Access Compliance Report

Public Rights-of-Way

(Curb Ramps)

Intersection ID: 47571	Main Street: SEDGEBURN_DR	Cross Street: HERMSLEY_RD	Location: SE
ADA ID: B6B27917615D	Ramp Type: PerpDiag	Initial Pass/Fail: Fail	Overall Compliance: No
Severity Score: 10			
Codes/Mitigation Info/Possible Solution		Field Measurements/Component Compliance

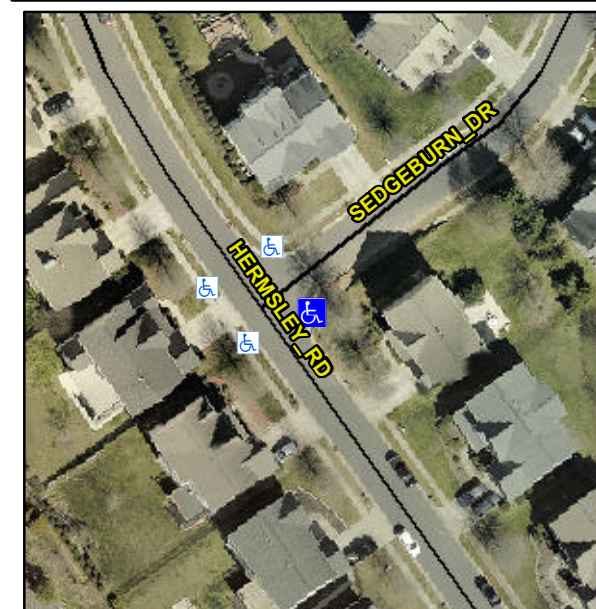
Not Found, R304.5.1, R304.5.3

Compliance	Description	Data	Compliance	Description	Data
N/A	Ramp Length (in)	48.0	Yes	Ramp Slope (%)	6.3
No	Ramp Width (in)	44.0	No	Ramp XSlope (%)	3.0
N/A	Flare Type LT	N/A	N/A	Flare Type RT	N/A
N/A	Flare Slope LT (%)	N/A	N/A	Flare Slope RT (%)	N/A
N/A	Flare Traversable LT?	N/A	N/A	Flare Traversable RT?	N/A
N/A	Landing Length (in)	N/A	N/A	DWS Provided?	N/A
N/A	Landing Width (in)	N/A	N/A	DWS Contrast?	N/A
N/A	Landing Slope (%)	N/A	N/A	DWS Length (in)	N/A
N/A	Landing X Slope (%)	N/A	N/A	DWS Full Width?	N/A
N/A	Landing Curb? (Y/N)	N/A	N/A	DWS Offset (in)	N/A
N/A	Shared Landing?	N/A			
N/A	Gutter Ponding?	N/A	N/A	Gutter Slope (%)	N/A
N/A	Gutter Lip Ht (in)	N/A	N/A	Gutter X Slope (%)	N/A
N/A	Painted X Walk1?	No	N/A	Painted X Walk2?	No
	X Walk 1 Direction	To NW		X Walk 2 Direction	To SW
N/A	X Walk 1 Width (in)	N/A	N/A	X Walk 2 Width (in)	N/A
	X Walk 1 Slope (%)	0.9		X Walk 2 Slope (%)	2.3
	X Walk 1 X Slope (%)	0.6		X Walk 2 X Slope (%)	3.3

Remove & Replace Curb Ramp With Two New Directional Ramps or Equivalent.
